1. PCI Standard Hot-plug Engineering Change Notice – SHPC Extensions for PCI-X 2.0

TITLE:	SHPC Extensions for PCI-X 2.0
DATE:	February 27, 2003
AFFECTED DOCUMENT(S):	PCI Standard Hot-Plug Controller and Subsystem Specification, Revision 1.0
SPONSOR:	Alan Goodrum, Hewlett-Packard, and Sridhar Muthrasanallur, Intel

Figure 3-xx01: PCI-X 266 and PCI-X 533 SHPC Slot Enable Sequence Bus Stabilization Timing, Phase 2

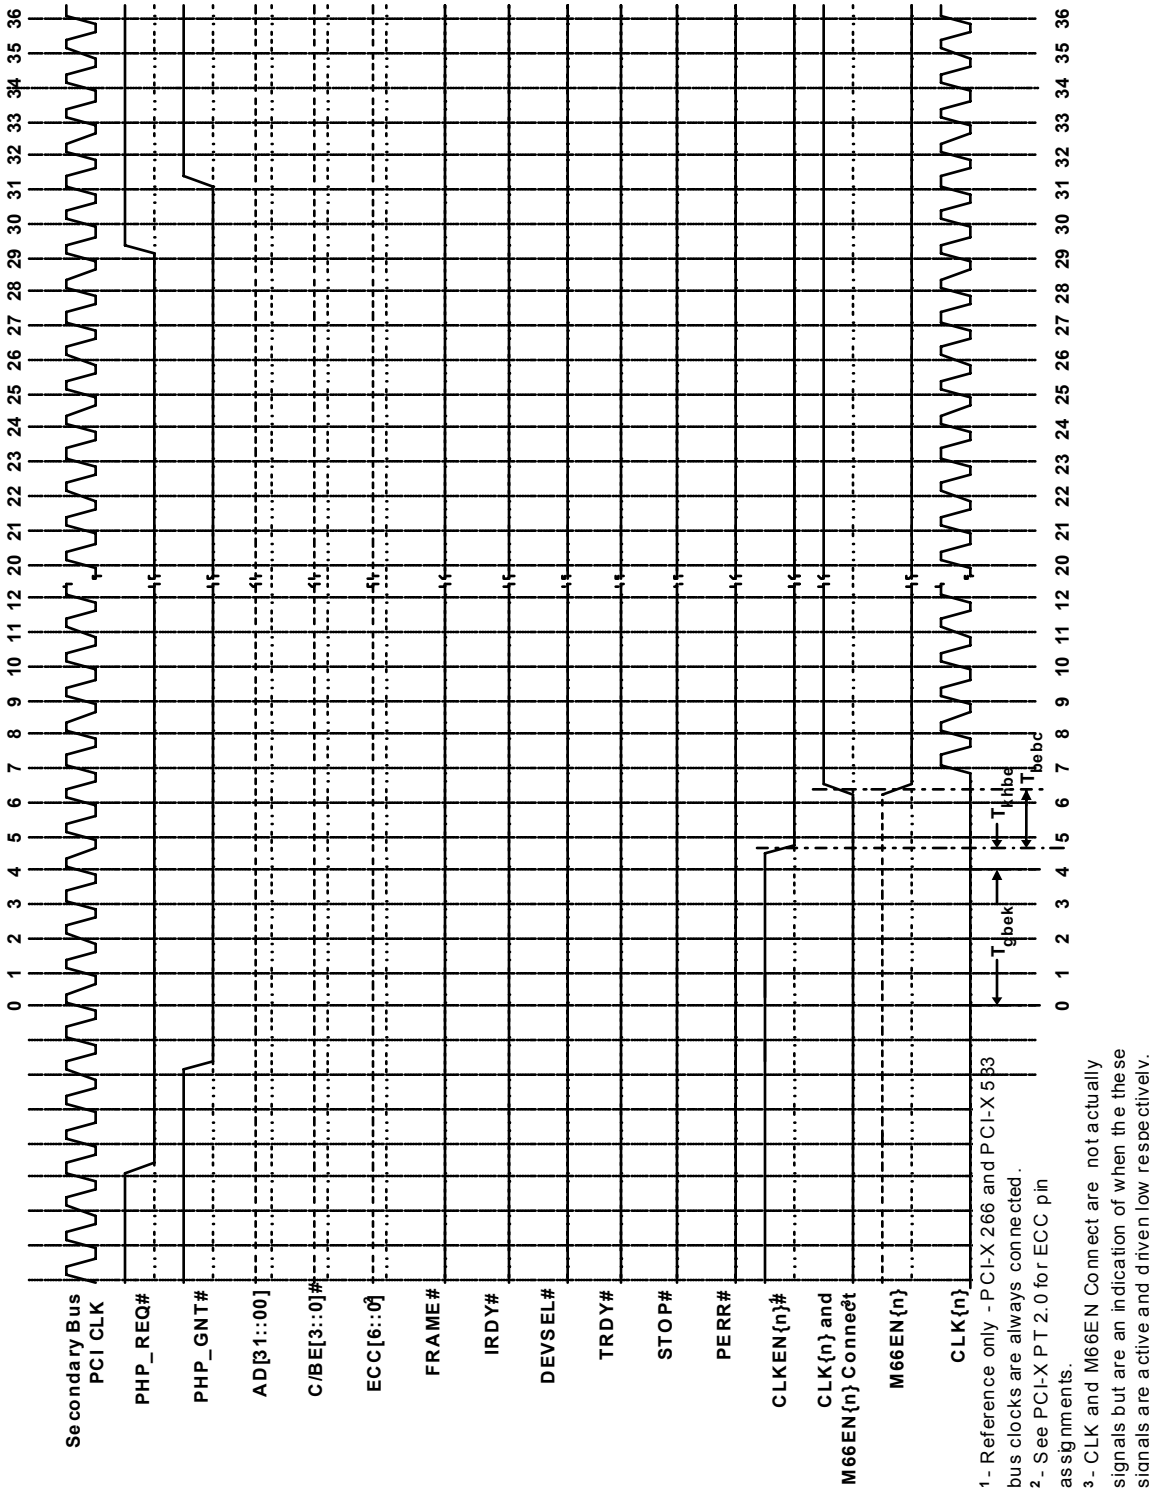
Change Instruction: Add the following figure after Figure 3-6 in Section 3.4.3:

Figure 3-xx02: PCI-X 266 and PCI-X 533 SHPC Slot Enable Sequence Bus Stabilization Timing, Phases 3 and 4

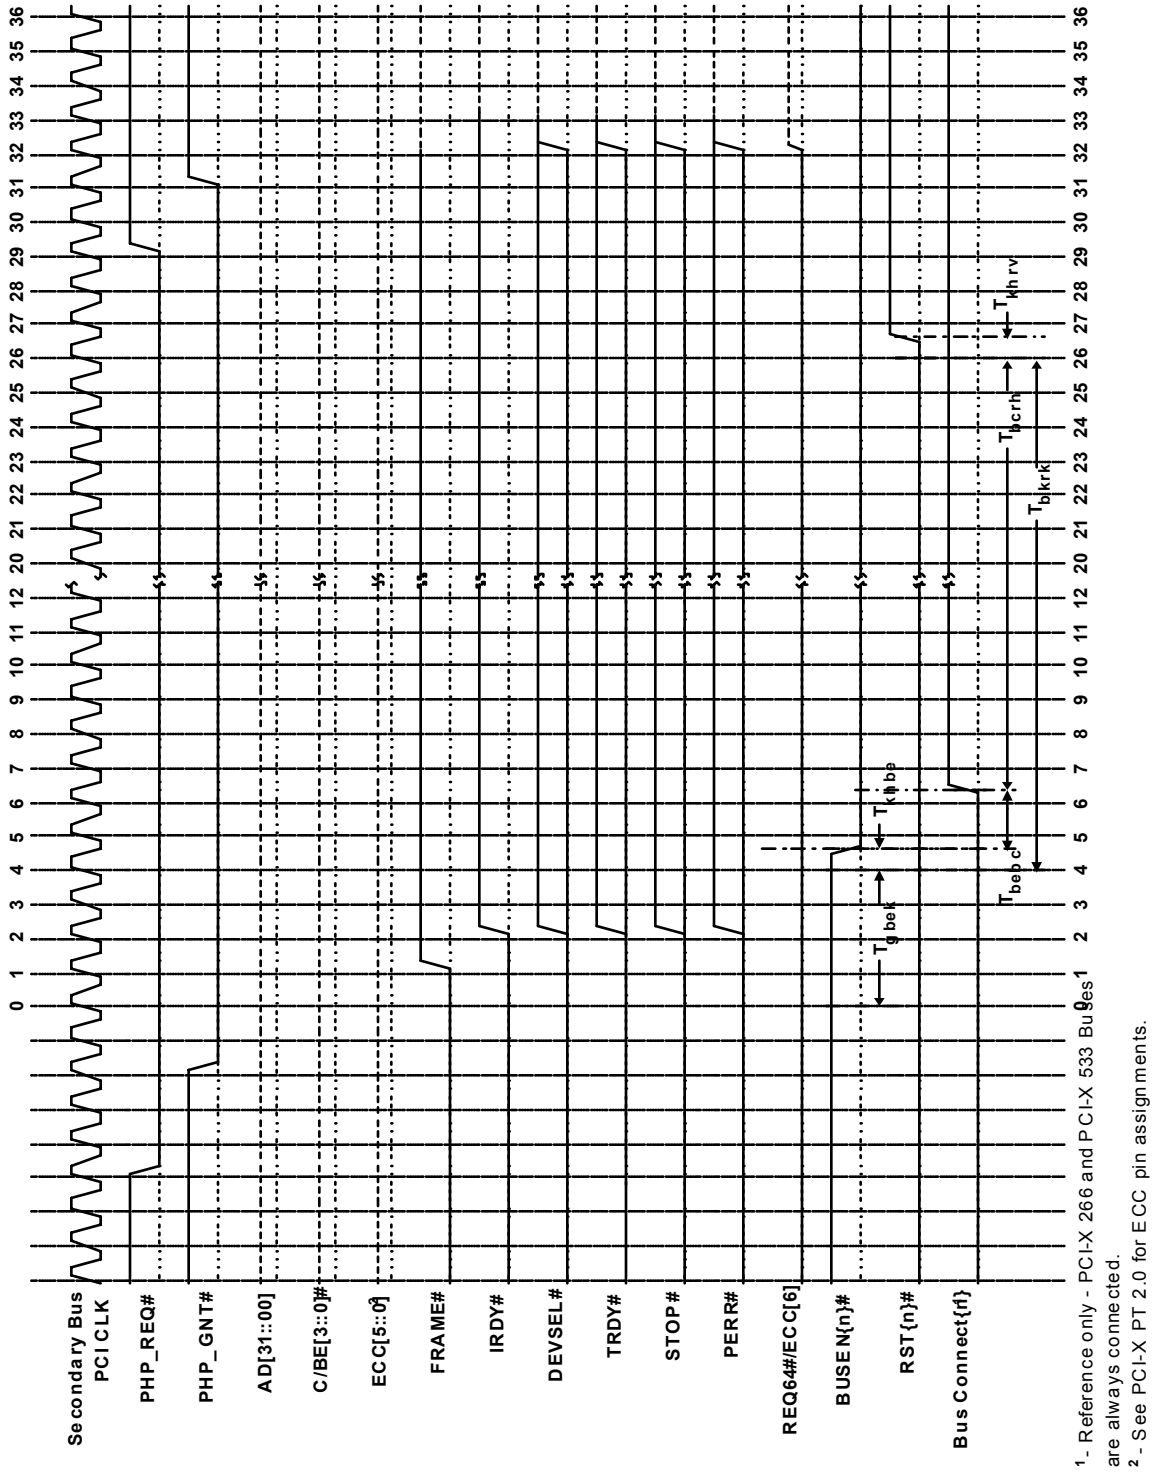
Change Instruction: Add the following figure after Figure 3-8 in Section 3.4.3:

Figure 3-xx03: PCI-X 266 and PCI-X 533 SHPC Slot Disable Sequence Bus Stabilization Timing, Phases 1 and 2

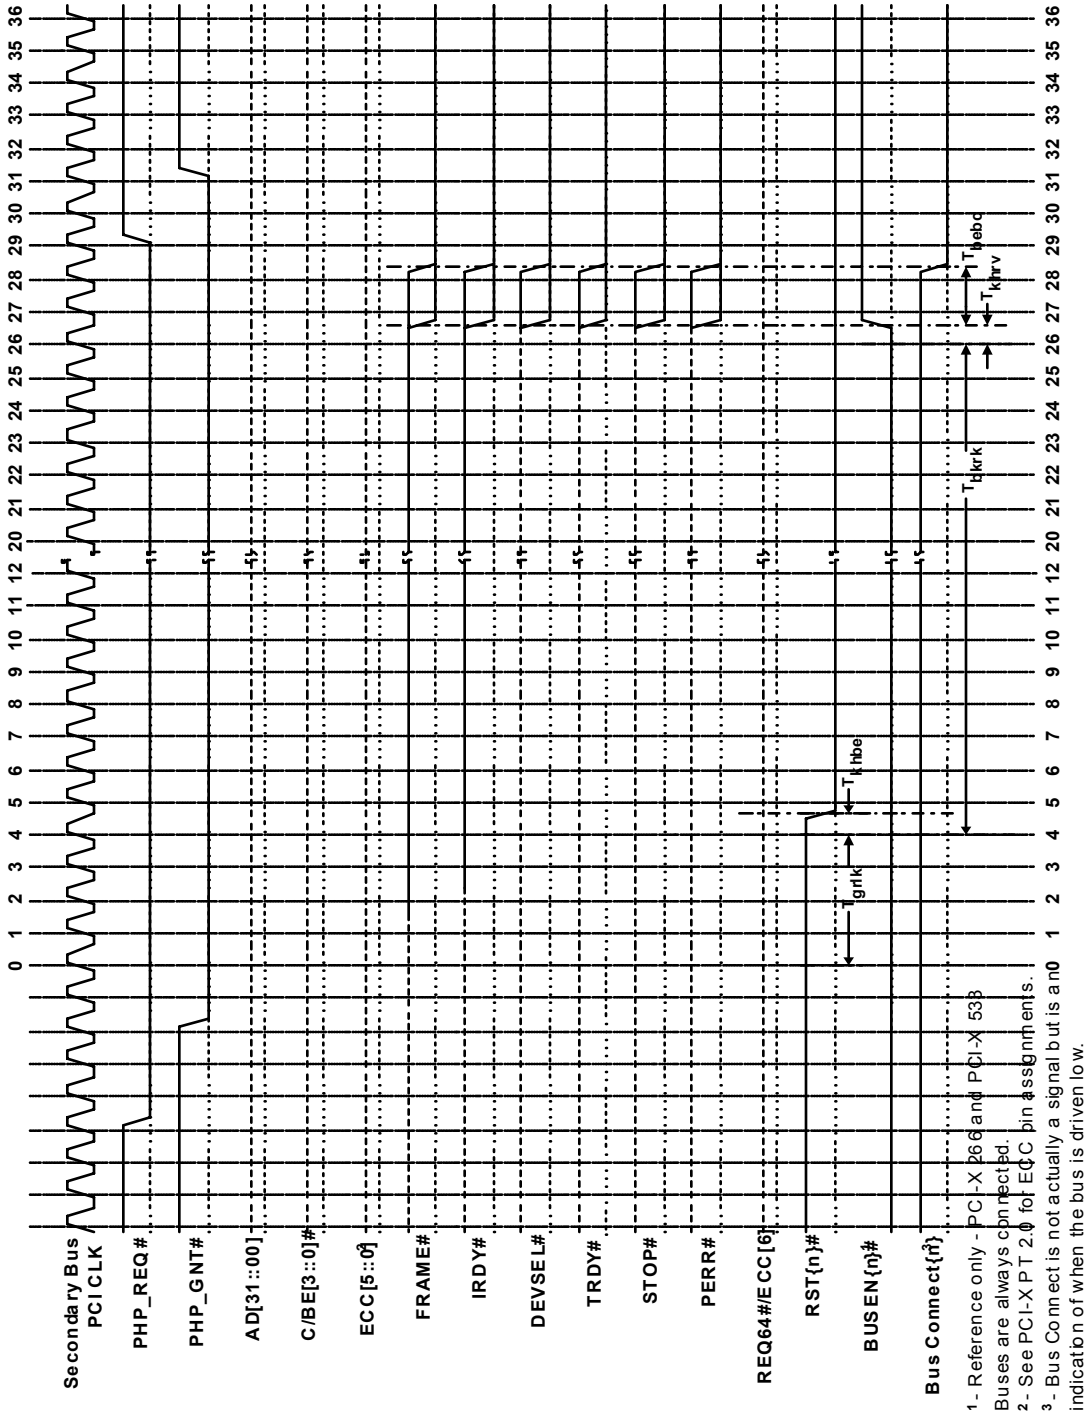
Change Instruction: Add the following figure after Figure 3-11 in Section 3.4.4 :

Figure 3-xx04: PCI-X 266 and PCI-X 533 SHPC Slot Disable Sequence Bus Stabilization Timing, Phase 3

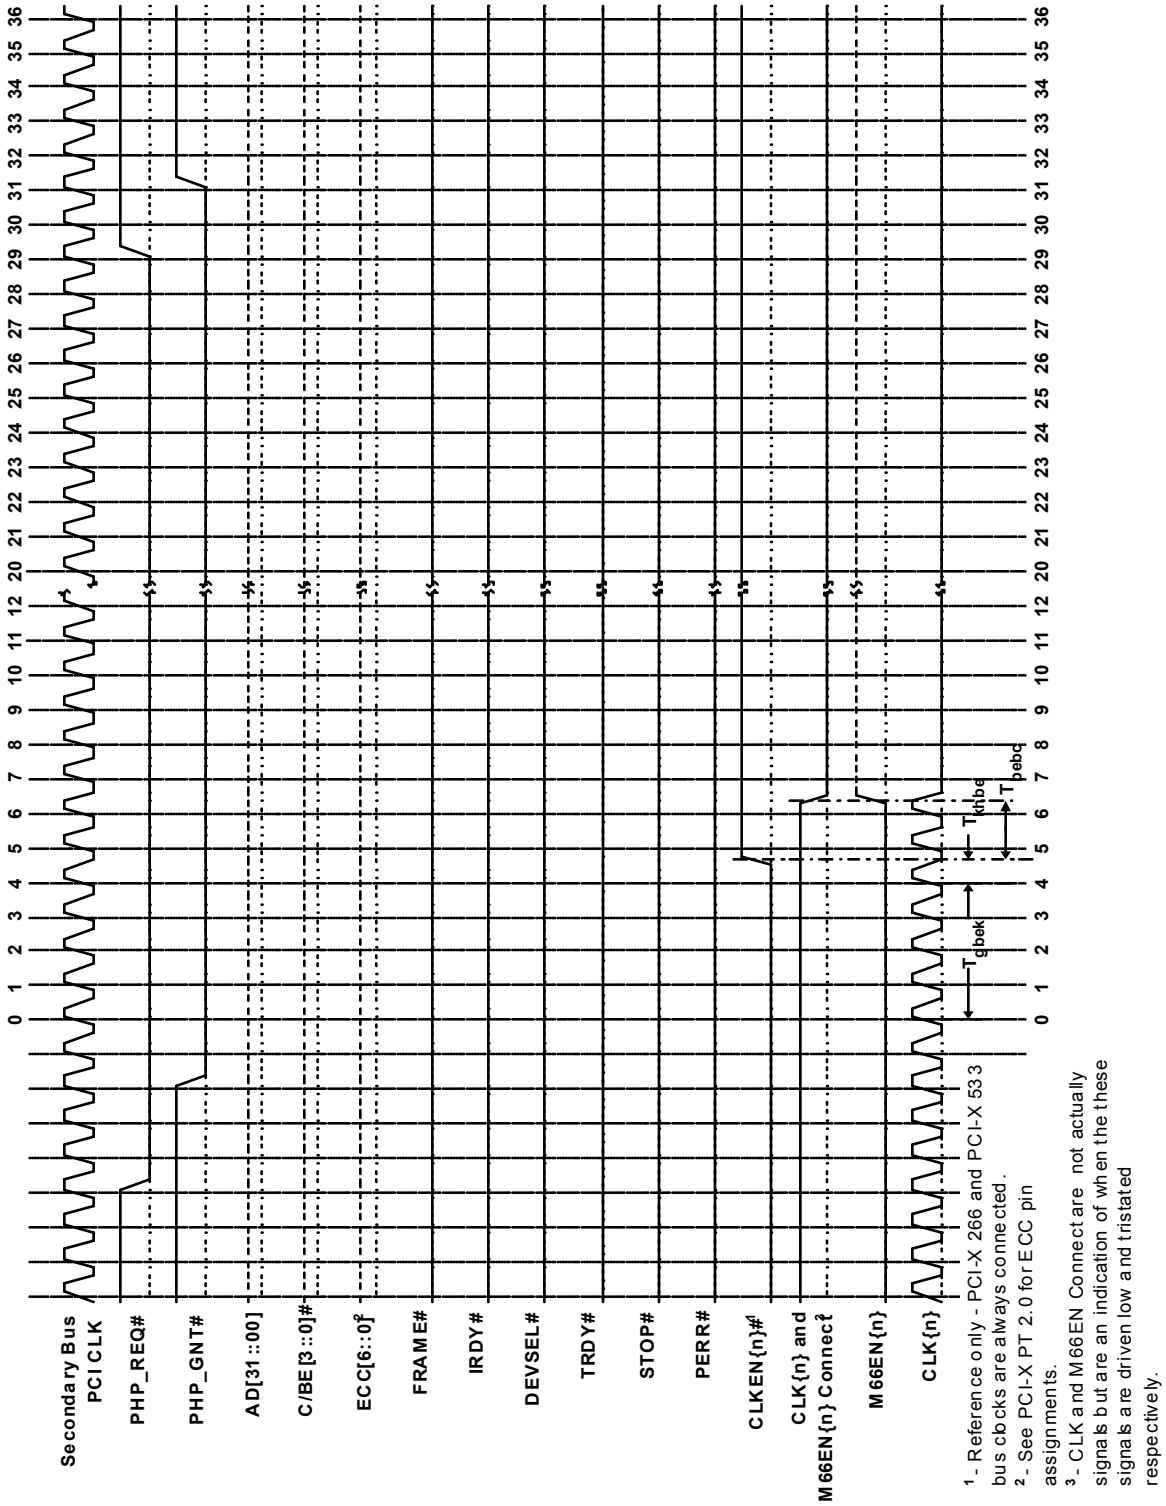
Change Instruction: Add the following figure after Figure 3-13 in Section 3.4.4:

Figure 3-xx05: PCI-X 266, PCI-X 533 Mode Deassertion of RST{n}# After a Bus Segment Reset or SHPC Set Frequency/Mode Command

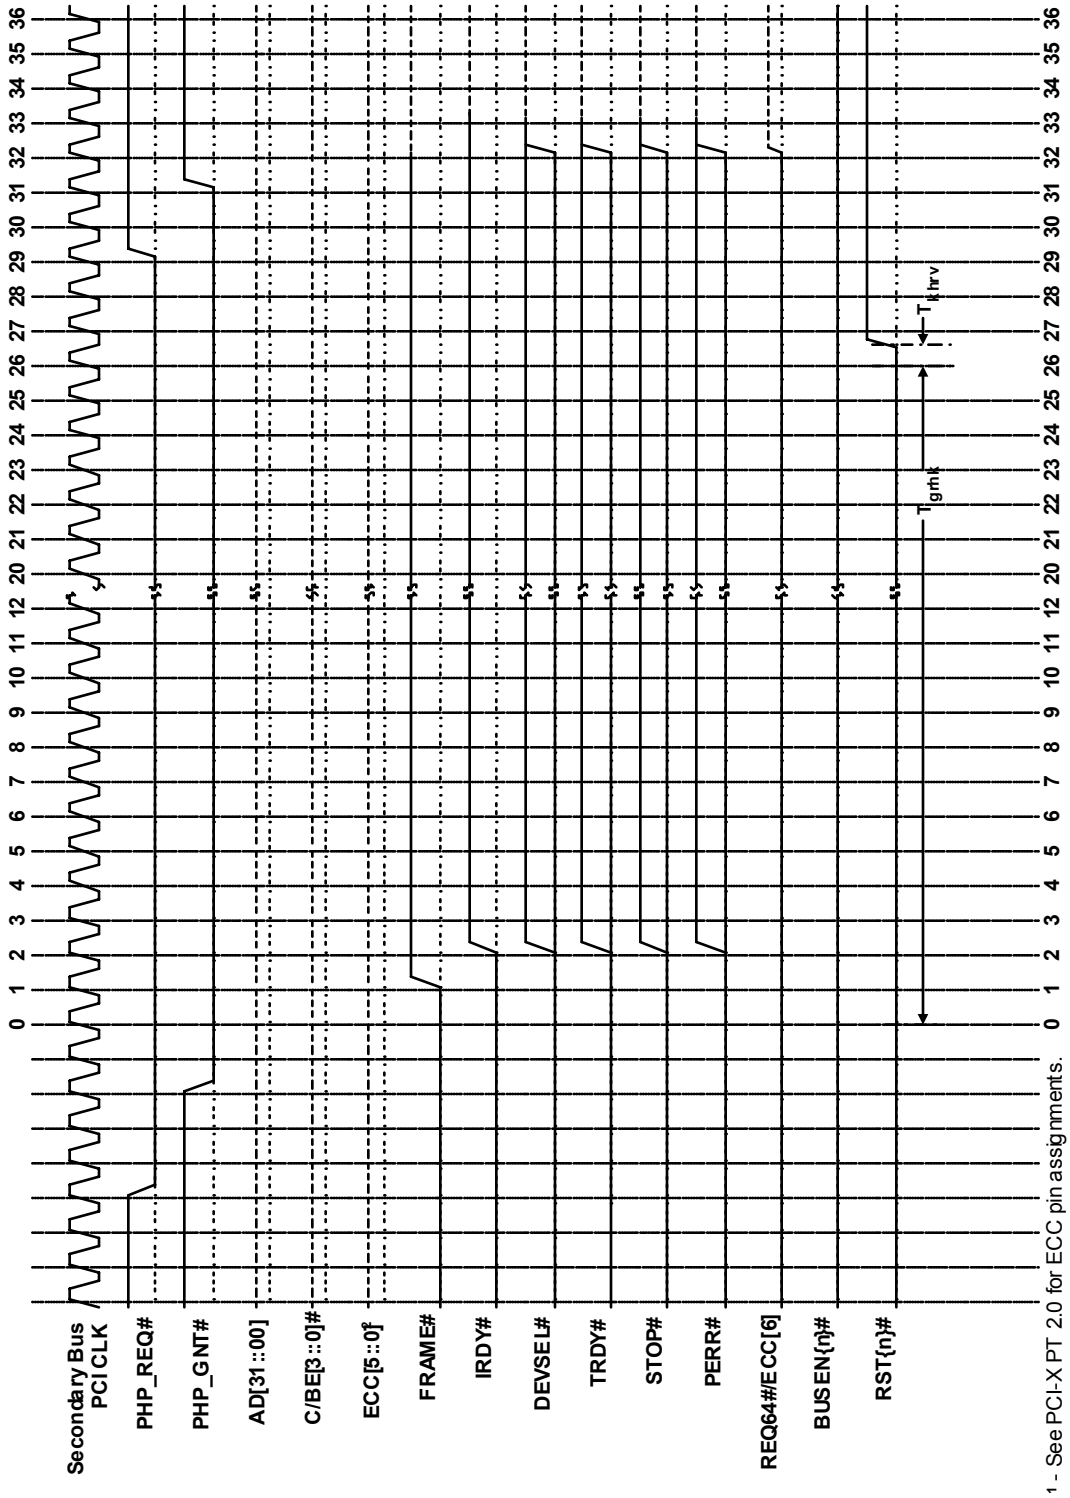
Change Instruction: Add the following figure after Figure 3-16 in Section 3.4.5:

Figure 4-12: Secondary Bus Configuration Register

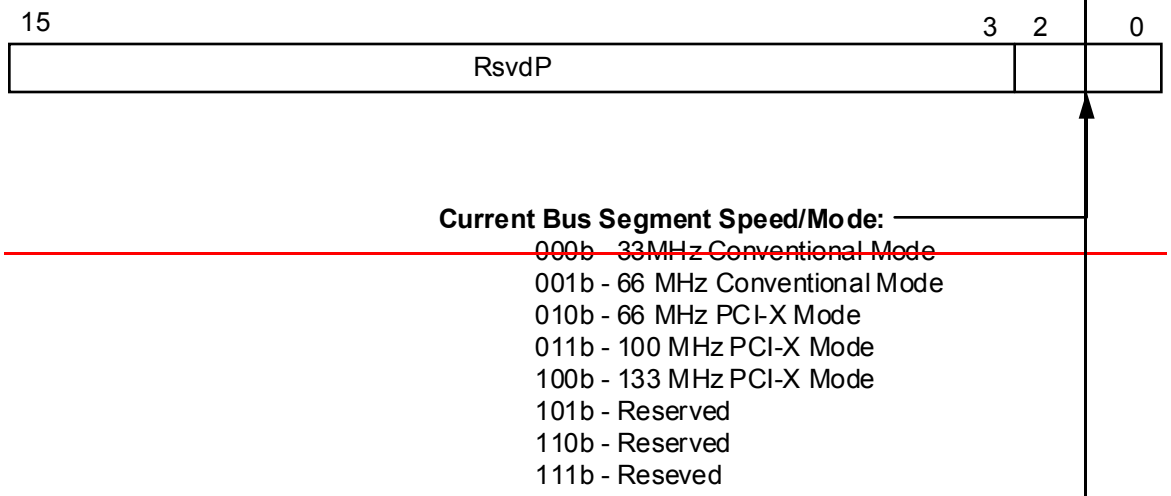
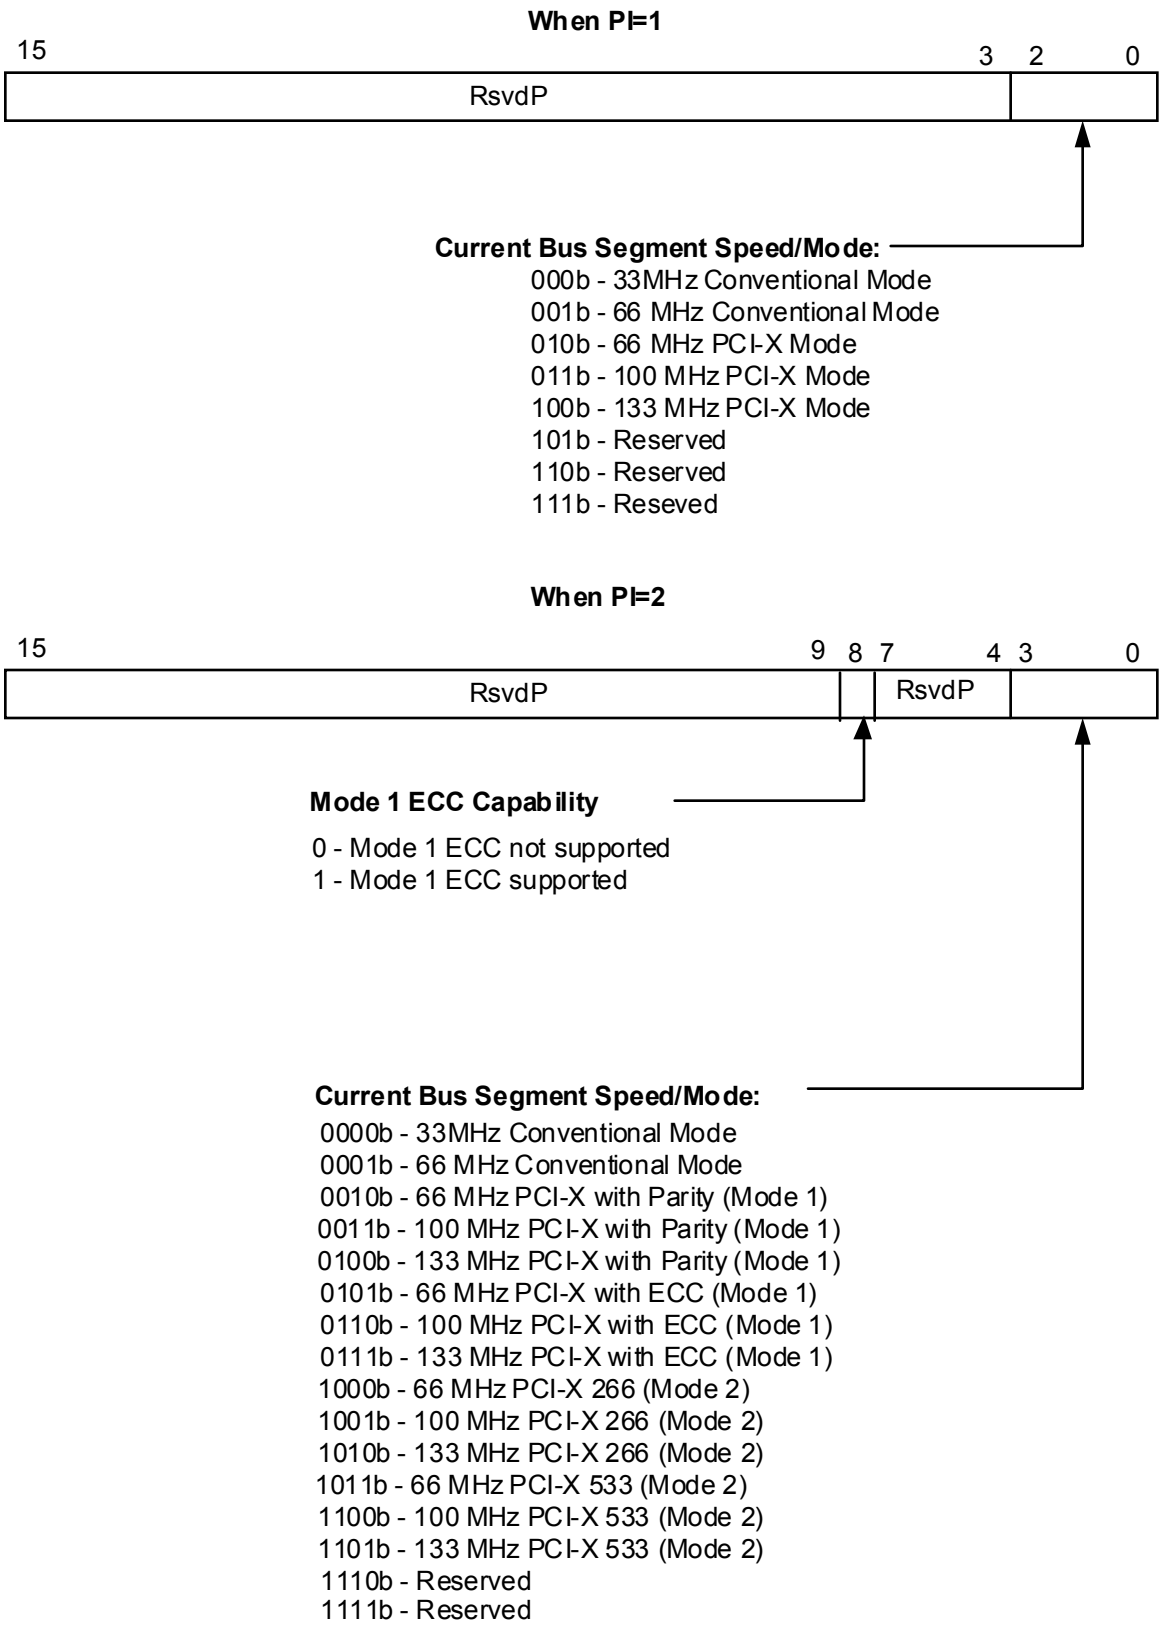
Change Instruction: Change Section 4.5.4 pg 115, as follows:

The Secondary Bus Configuration register describes the configuration of the secondary bus segment that contains the hot-plug slots controlled by the SHPC. Bit definitions in this register are dependent on the value of the SHPC Programming Interface (PI) register at Byte Offset 13h.
